Access Compliance Report

Public Rights-of-Way

(Curb Ramps)

Intersection ID: 44000		Main Street: ELROSE_PL		Cross Street: GANDER_DR		Location: NE			
ADA ID: A21EC8D686E3		Ramp Type: PerpDiag		Initial Pass/Fail: Fail		Overall Compliance: No		Severity Score: 25	
Codes/Mitigation Info/Possible Solution					Field Measurements/Component Compliance

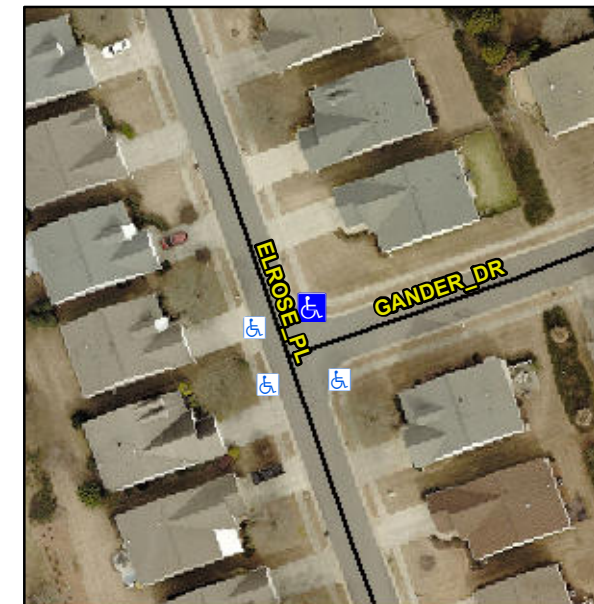
Not Found, R304.2.2, R304.5.3

Compliance	Description	Data	Compliance	Description	Data
N/A	Ramp Length (in)	48.0	No	Ramp Slope (%)	8.7
Yes	Ramp Width (in)	48.0	No	Ramp XSlope (%)	6.1
N/A	Flare Type LT	N/A	N/A	Flare Type RT	N/A
N/A	Flare Slope LT (%)	N/A	N/A	Flare Slope RT (%)	N/A
N/A	Flare Traversable LT?	N/A	N/A	Flare Traversable RT?	N/A
N/A	Landing Length (in)	N/A	N/A	DWS Provided?	N/A
N/A	Landing Width (in)	N/A	N/A	DWS Contrast?	N/A
N/A	Landing Slope (%)	N/A	N/A	DWS Length (in)	N/A
N/A	Landing X Slope (%)	N/A	N/A	DWS Full Width?	N/A
N/A	Landing Curb? (Y/N)	N/A	N/A	DWS Offset (in)	N/A
N/A	Shared Landing?	N/A			
N/A	Gutter Ponding?	N/A	N/A	Gutter Slope (%)	N/A
N/A	Gutter Lip Ht (in)	N/A	N/A	Gutter X Slope (%)	N/A
N/A	Painted X Walk1?	No	N/A	Painted X Walk2?	No
	X Walk 1 Direction	To SW		X Walk 2 Direction	To SE
N/A	X Walk 1 Width (in)	N/A	N/A	X Walk 2 Width (in)	N/A
	X Walk 1 Slope (%)	6.8		X Walk 2 Slope (%)	4.0
	X Walk 1 X Slope (%)	0.5		X Walk 2 X Slope (%)	4.9

Remove & Replace Curb Ramp With Two New Directional Ramps or Equivalent.
